Form 3160-5
(June 2019)

SUNDRY NOTICES AND REPORTS ON WELLS
Do not use this form for proposals to drill or to re-enter an abandoned well. Use Form 3160-3 (APD) for such proposals.

EOG respectfully requests an amendment to our approved APD for this well to reflect the following changes:

Stonewall 28 Fed Com 513H (FKA 406H) API #: 30-025-52705

Revised Wellbore

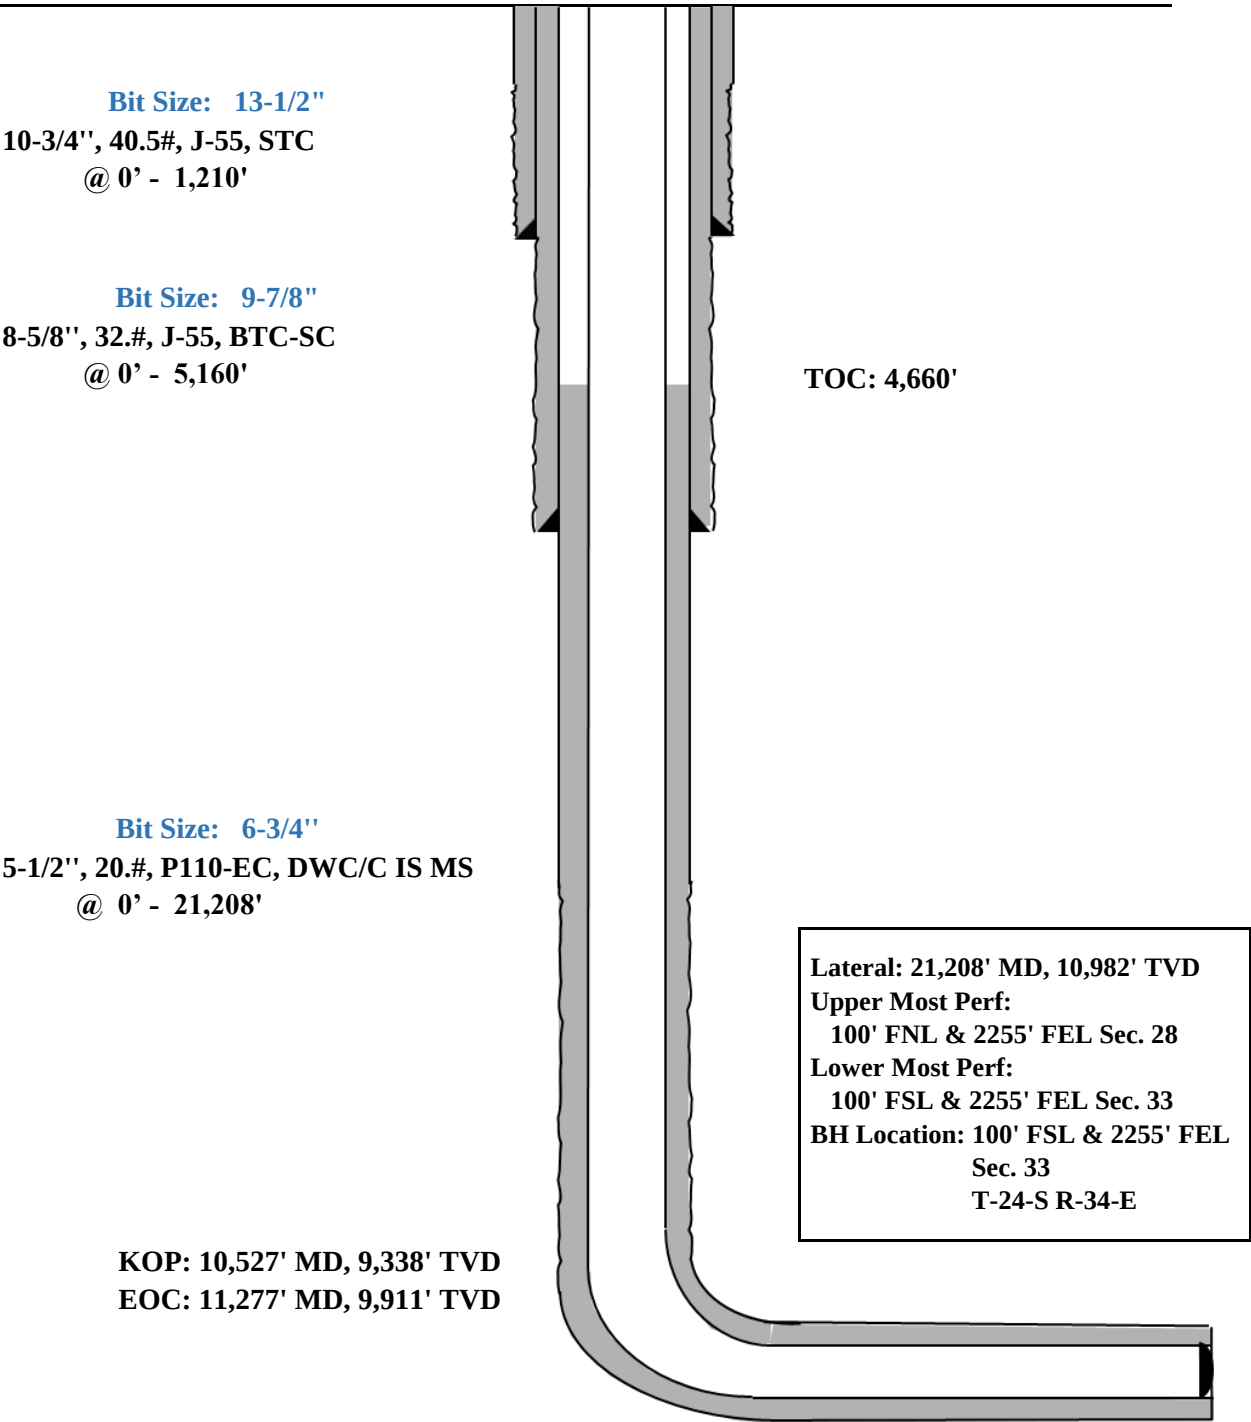
Change name from Stonewall 28 Fed Com 406H to Stonewall 28 Fed Com 513H.

Change BHL from T-24-S, R-34-E, Sec 33, 100' FSL, 1650' FEL, Lea Co., NM, to T-24-S, R-34-E, Sec 33, 100' FSL, 2255' FEL, Lea Co., N.M.

Change target formation to Second Bone Spring Sand.
